AN/SPS-39, 42 RADAR-IMPROVED TWT OPERATION

SUBSTITUTE VARIABLE RESISTOR FOR AN/SPS-39/42 (XN-1)

AN/SPS-39, 42 RADARS TWT OPERATION -- SUPPLEMENTARY INFORMATION (132 POWER SUPPLY ADJUSTMENT PROCEDURE)

Figure 1

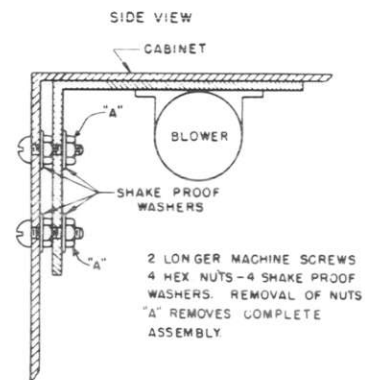
The following suggestion will substantially reduce the time required to change the blower motor in AN/UPX-1 equipments.

In the existing installation the blower motor bracket is secured to the back of the cabinet, requiring the removal of the cabinet and associated wiring in order to replace the blower.

The suggested change replaces the two machine screws holding the blower bracket with longer screws.

Shake proof washers and hex nuts are run down and tightened, after which the bracket and motor blower is set in place and secured with shakeproof washers and hex nuts. (See figure 1).

Figure 1

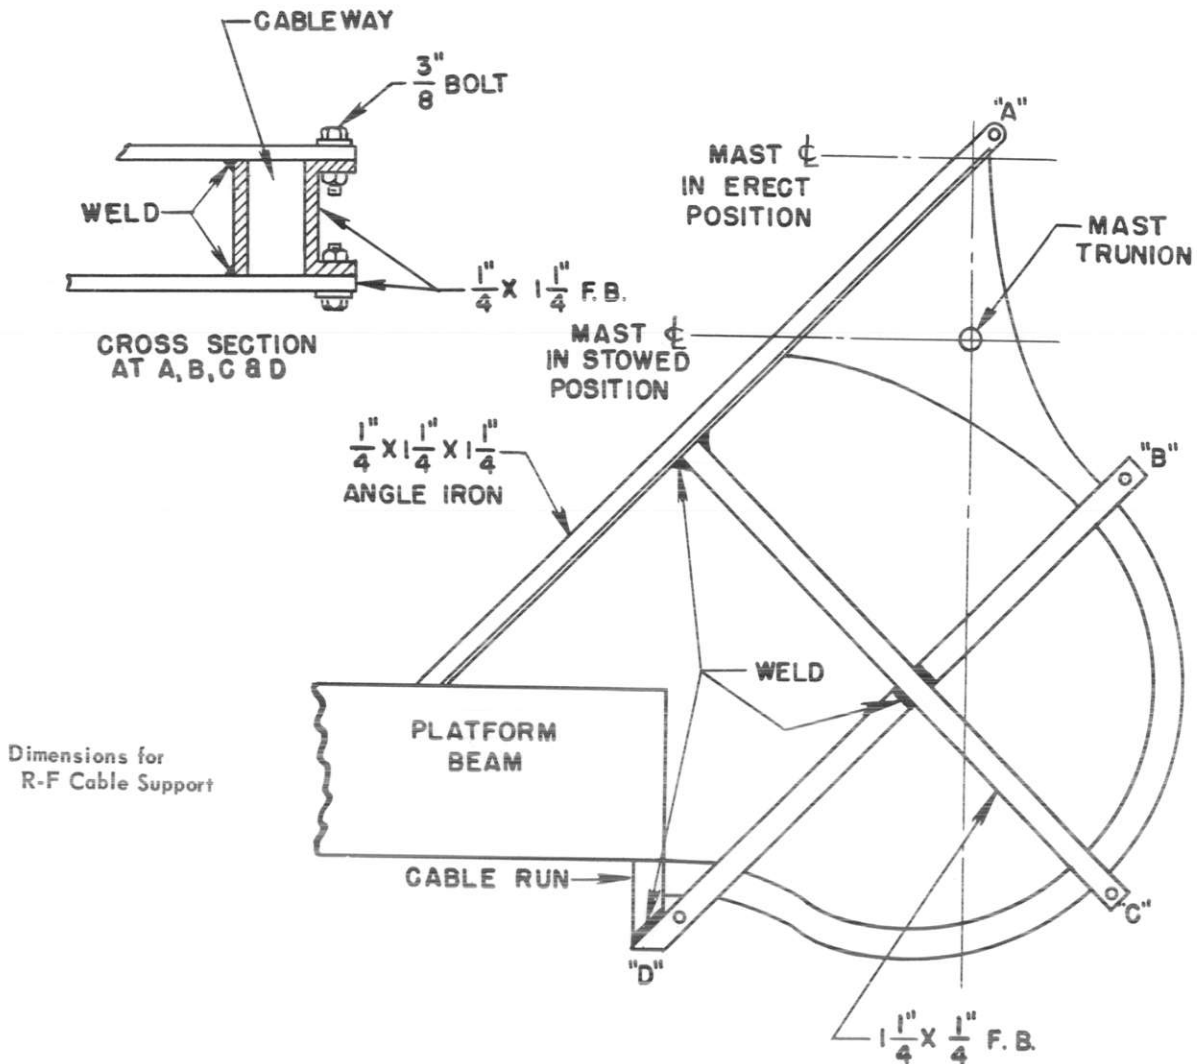
An improved method for supporting Radio-Frequency Cable, RG/24U, at the fulcrum of the tilting mast of DAU equipment by means of a cable support. This method was used successfully for installing the DAU on the USS Essex (CVA9). The cable support is described herein is shown in figure 1. It requires only a 45-degree flexure of the cables on a long (20 in.) radius on each side of the straight position during the entire process of erecting and stowing the mast.

The proposed cable support requires less cable since there is no slack-loop, and a minimum radius is used in bringing the cable-run from underneath the operating platform up to the mast. The cable support is stationary, and only the cable moves with the mast. A demountable outer guard on the cable support permits inspection or replacement of the cables.

The Bureau recommends the use of this suggestion for any future installations of DAU equipment on tilting masts in CV34 Class Carriers. The suggestion will be included in the next revision of the **Electronics Installation Practices Manual**, NAVSHIPS 900,171, as a guiding principle for future installations. As tilting masts are used on a relatively few aircraft carriers, installation plans will not be changed and modification of existing installations is not recommended.

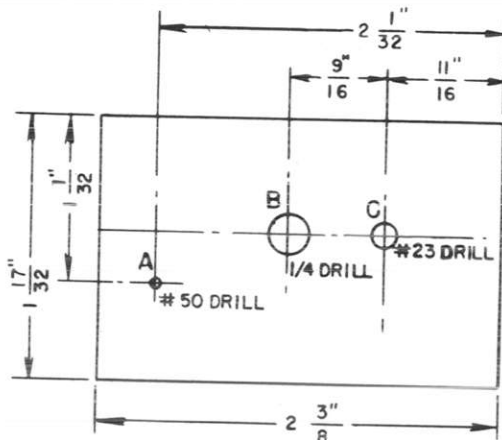
Route each wire between the capacitors toward and between the base of the 5R4 tubes (V-6576 and V-6577).

Re-dress each wire to its tie point.

Replacing is only necessary from the transformer to the base of the 5R4 tubes.

FRONT VIEW OF PANEL (RDJ) SHOWING TEMPLATE IN PLACE

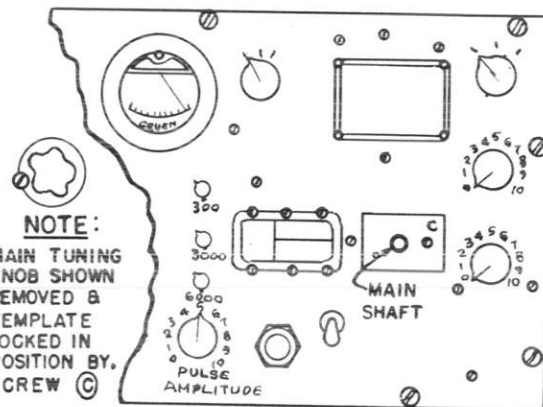
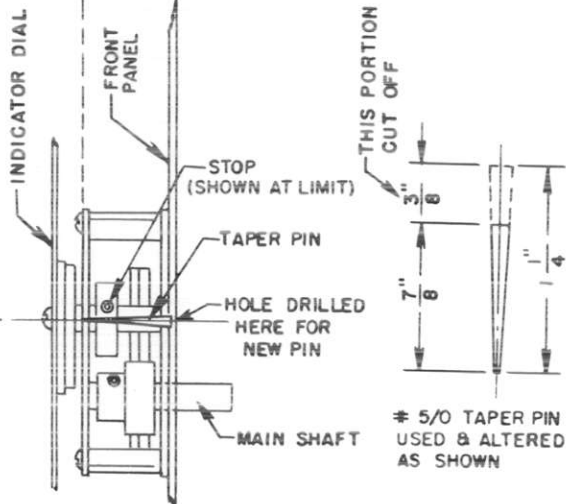
It has been necessary to remove the front panel of Radar Pulse Analyzing Equipment RDJ to replace the limit stop of the elliptical sweep tuning capacitor when the stop becomes broken.

A method by which these pins may be removed and replaced without removing the front panel has been suggested. This can be done by modifying the present limit stop system as shown in the figure and by following the accompanying instructions.

This modification may be made when it will facilitate maintenance of the RDJ-1. In view of the obsolescence of the equipment, no field change will be issued.

TEMPLATE SHOULD BE APPROX. 1/16" THICK EXACT DIMENSIONS ARE SHOWN COUNTERSINK

HOLE C FOR #6 FLAT HEAD MACH. SCREW
HOLE B USE 1/4 DRILL
HOLE A USE #50 DRILL

Figure 1

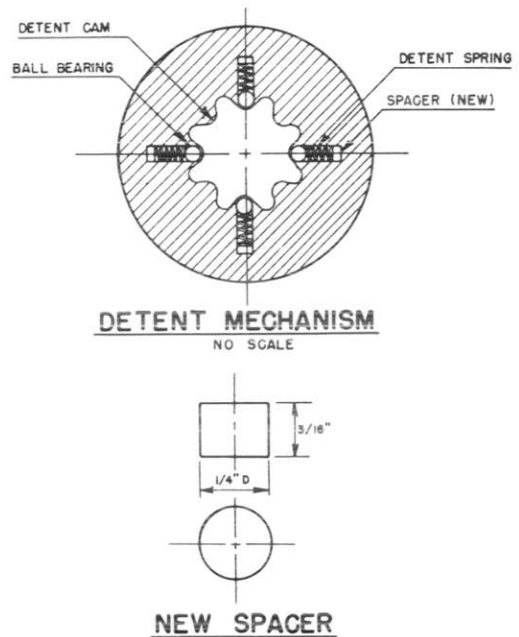
Addition of spacers, as shown in figure 1, will increase the spring tension and allow proper operation of Rotary Switch SA-213/U.

Figure 1 - Door Closing without Cable Spring.

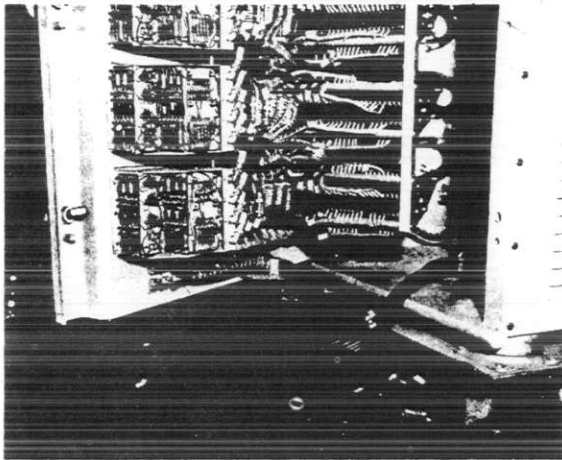
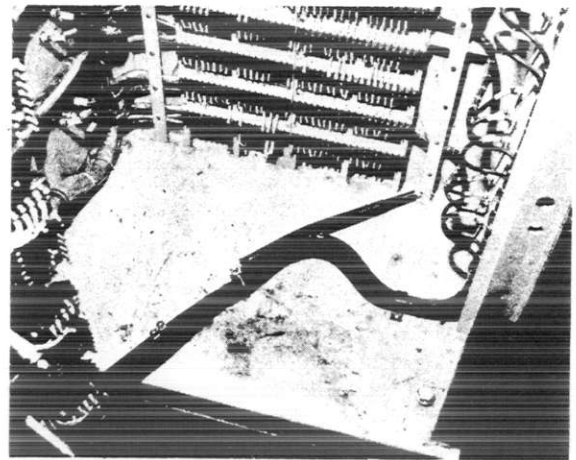
A modification to prevent crushing of video and trigger cables when closing doors of Radar Distribution Switchboards SB-416, -416A/SP has been submitted. The following material is needed to accomplish this modification:

The photos, show the door closing with, and without, the cable spring and the spring and clamp in operation.

1. One close wound spring 5/8" O.D., 12" long, No. 14 spring wire.
2. One 12" piece of 3/4" synthetic tubing to insulate spring.
3. One Timmerman No. 19A insulated cable slip, or equivalent.
